VIRGINIA ELECTRIC AND POWER COMPANY
RICHMOND, VIRGINIA 23261

VIRGINIA ELECTRIC AND POWER COMPANY
NORTH ANNA POWER STATION UNIT NOS. 1 AND 2
REQUEST FOR ADDITIONAL INFORMATION
CORE UPDATING

RESPONSE TO NRC REQUEST
FOR ADDITIONAL INFORMATION

TABLE 1
PLANT COMPARISON

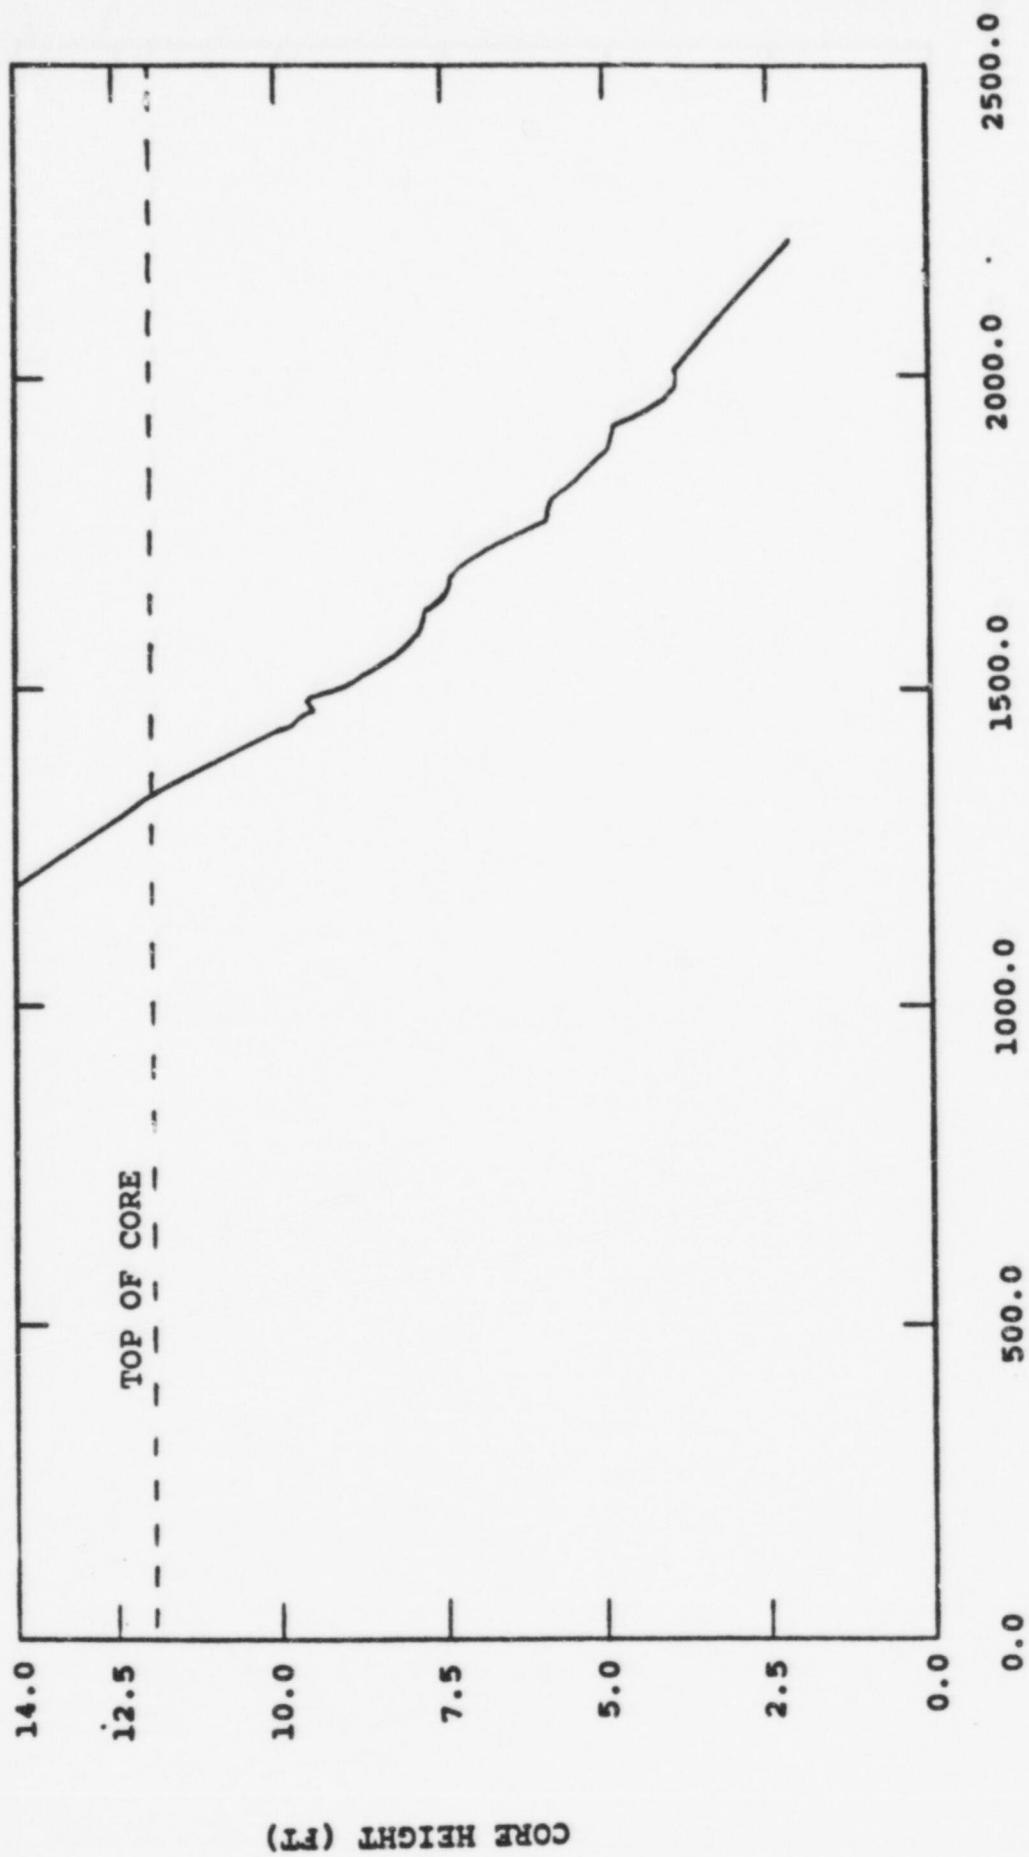
Page 24 of Attachment 1 to your letter of February 6, 1986 refers to a two-inch small break LOCA analysis for a plant similar to North Anna. Provide this analysis or an available reference and justify that this plant is similar.

The analysis was performed for a 3-loop plant which is similar to North Anna Units 1 & 2. A comparison of the two plants is shown in Table 1. The minor differences between the two plants and their impact on the applicability of this analysis to North Anna are discussed in a later section.

Examination of Table 1 shows that the 3-loop reference plant used in the analysis described above is very similar to North Anna Units 1 & 2. The minor differences between the two plants and their impact on the applicability of these results of North Anna are discussed below.

The uprated North Anna Units have a full power rating which is 4.43% higher than the reference plant. This full power difference is insignificant when the results of this analysis are extrapolated to hot standby or hot shutdown initial conditions and their corresponding decay heat levels. For example, at the time of core uncover the decay heat level of the reference plant full power analysis is approximately 65.86MWt (2.3% of full power), whereas when North Anna is in a hot standby or hot shutdown mode of operation the decay heat level is expected to be no more than 40.37MWt (1.36% of full power) or 35.25MWt (1.19% of full power), respectively. Consequently, the 22.12 minute time frame to core uncover calculated for the full power case is a conservative minimum estimate for the time to core uncover for SBLOCA's that may initiate from hot standby or hot shutdown initial conditions. Based on a comparison of power levels alone, it is expected that a more realistic time to core uncover for hot standby or hot shutdown initial conditions would be greater than 36 minutes.

The two plants employ different model steam generators. The differences between the models is largely due to different secondary side feedwater and steam separator design features which have insignificant impact on the plant's response to a SBLOCA.

Both plants contain 17x17 fuel, however, the reference plant was analyzed with Optimized Fuel Assembly (OFA) fuel, whereas, North Anna has standard fuel. This fuel difference accounts for a small portion of the core volume difference between the two plants (the majority of the core volume difference is due to differences in barrel-baffle design). The differences in power density between the two fuel types has an insignificant impact on the thermal-hydraulic response of the RCS during a SBLOCA.

A comparison of the reactor vessels shows that the volume distribution is slightly different between the two plants, but that the total vessel volume differs by only 1.17%. The volume distribution difference between the two plants is primarily the result of different barrel-baffle and upper head design configurations. The differences in volume distribution below the top of the core will be insignificant prior to core uncover. An examination of the volume above the core, i.e. the upper head and upper plenum volumes, shows that North Anna has approximately 8% more volume above the core. As a result, for the North Anna Units, 8% more water (as compared to the reference plant) must boil-off or be lost through the break before core uncover will occur. Consequently, the elapsed time to core uncover for North Anna would be longer than the 22.12 minutes calculated for the reference plant.
